IMPROVEMENT ON PRODUCT	Automatic coupling E57
PART NUMBER	GE575A0 – GE576A0

NEW PART NUMBER	E575A0M – E576A0M
FROM DELIVERIES	now available

UPPER AND LOWER BELL-MOUTH

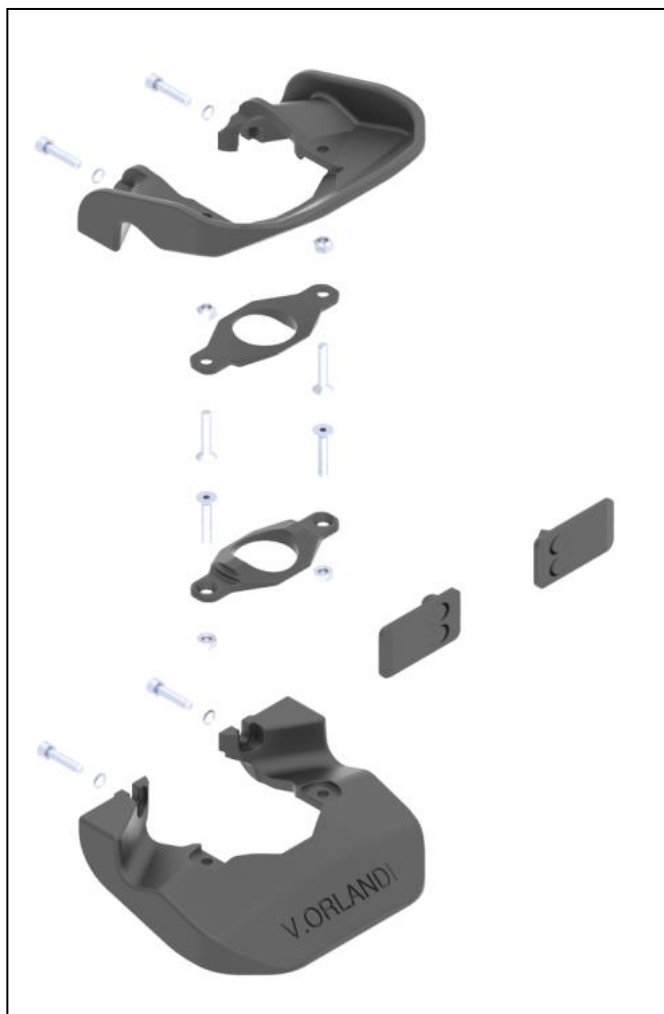
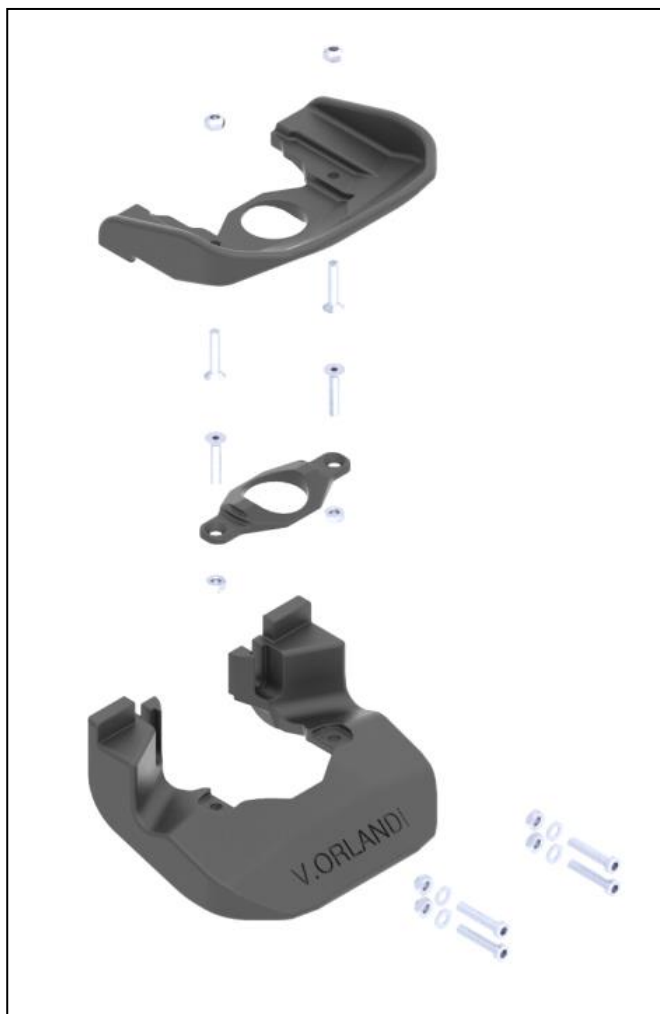
- Upper and lower bell-mouth will be cast steel, instead of cast iron;
- The shape of the lower bell-mouth is designed to simplify the coupling operation;
- Inserts (p/n RG00446) are not requested, thanks to the new lower bell-mouth's design;
- Upper wearing pad is integrated to the upper bell-mouth. We will provide, as spare part, only the lower kit wear-pad.
